room2 Homotel: Manchester Piccadilly

Design and Access Statement Addendum (Updated) – July 2024

Document Title	HMP-BA-XX-XX-TRP-A-0004 - Design and Access Statement Addendum (Updated)
Company	Bennetts Associates
Revision	P04
Date	9 th July 2024
Details	Design And Access Statement Addendum updated to address Case Officer comments issued on 13 th June 2024.
Document Number	HMP-BA-XX-XX-TRP-A-0004
Address	Bennetts Associates 38-42 Mosley Street Manchester M2 3AZ

Extracts from the updated submission drawing noting the details as described above / adjacent.

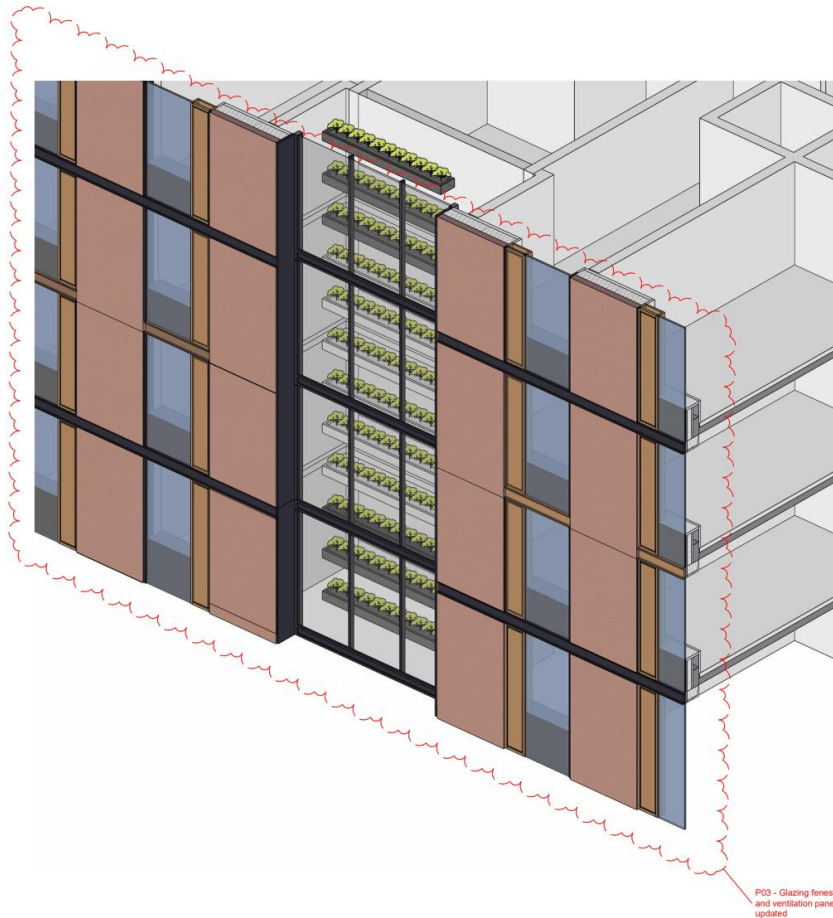
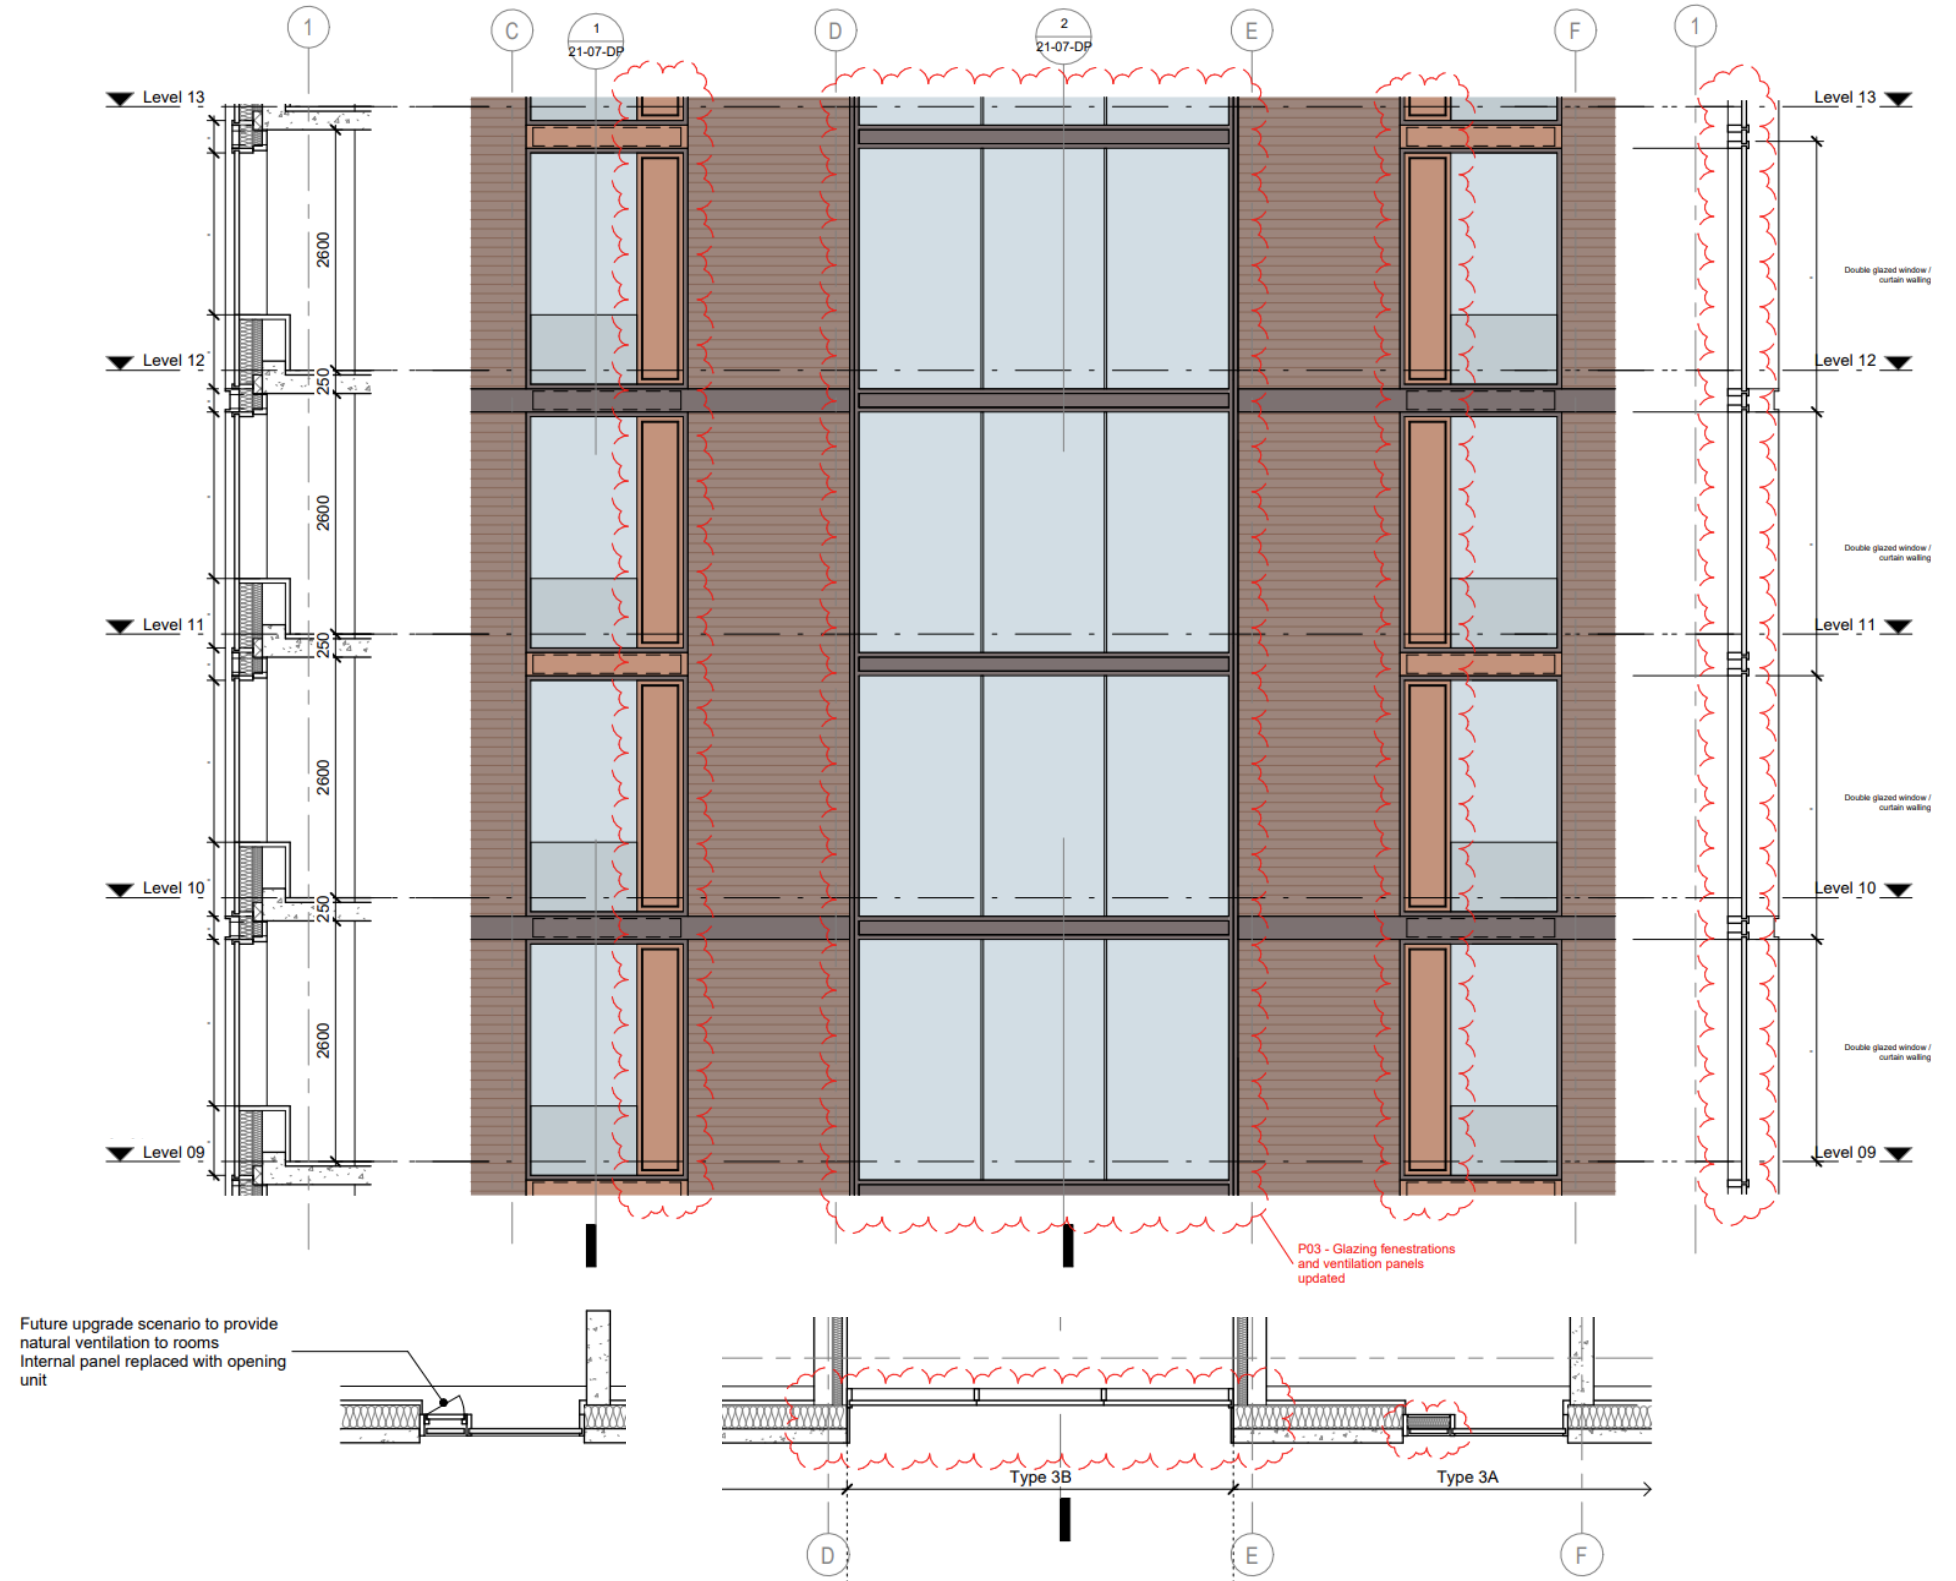
There is a note on the drawings that the side panel to the windows is futureproofed as a vent - can we have more clarity on this as it could change the fixing details / interfaces. Can it be confirmed either way if this is needed and ensure the detailing is accurate.

The strategy to futureproof the ventilation by allowing internal elements of the window to be replaced to facilitate natural ventilation of the rooms was explained at the meeting with the Case Officers on 2nd July 2024.

The design aims to conceal these flexible elements behind the external cladding with a potential future air path around perimeter of fixed panel. The façade design will be developed in more detail around these principles in the next stage.
